Charlotte Department of Transportation

Memorandum

Subject: Rezoning Petition 15-056: Approximately 1.92 acres located on the north side of Central Avenue between Nandina Street and Landis Avenue.

Figure 1

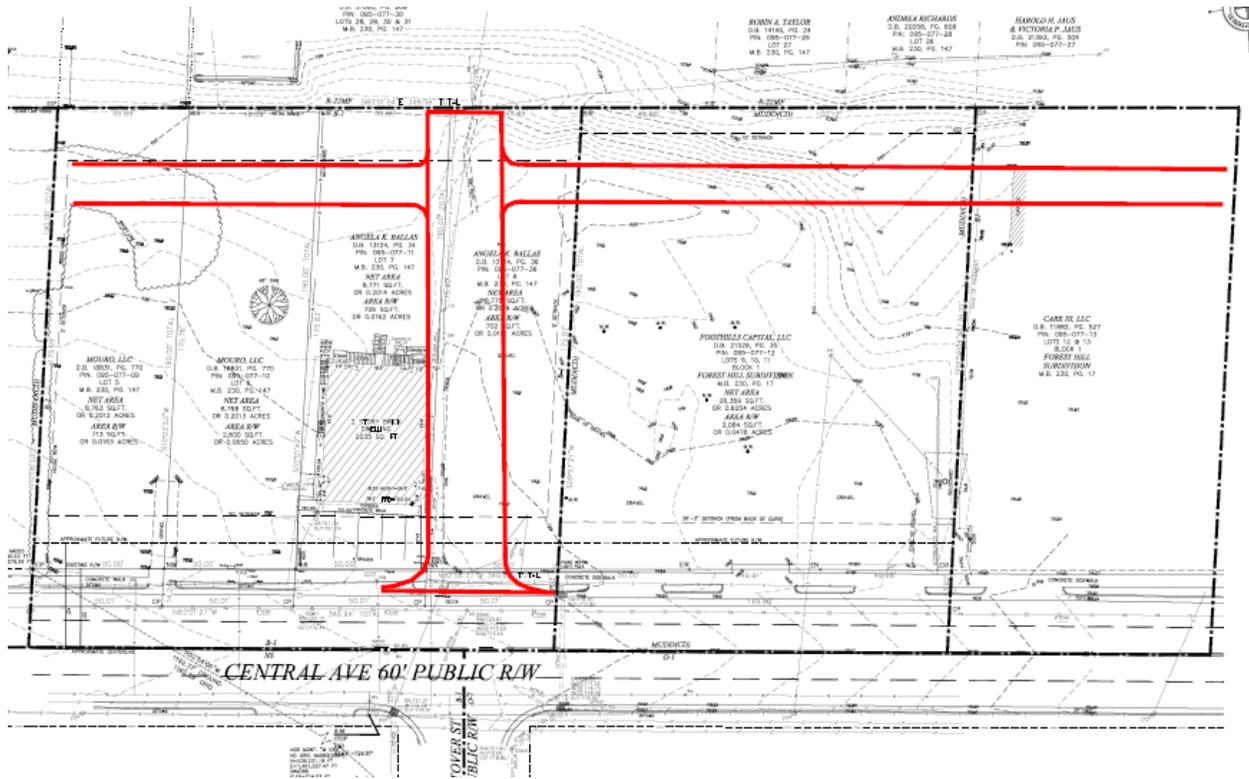
1. The preferred block spacing in a growth corridor is 600'. The existing block length from Landis to Nandina is over twice this distance. CDOT request the petitioner provide a public street (local residential wide per the Charlotte Land Development Standards Manual) that extends from Central Avenue to Parcel #09507730 as generally illustrated on Figure 1 below. The proposed driveways shown on the rezoning site plan could be relocated to the back of the parcels and tie into the extension of Westover Street (Figure 1).
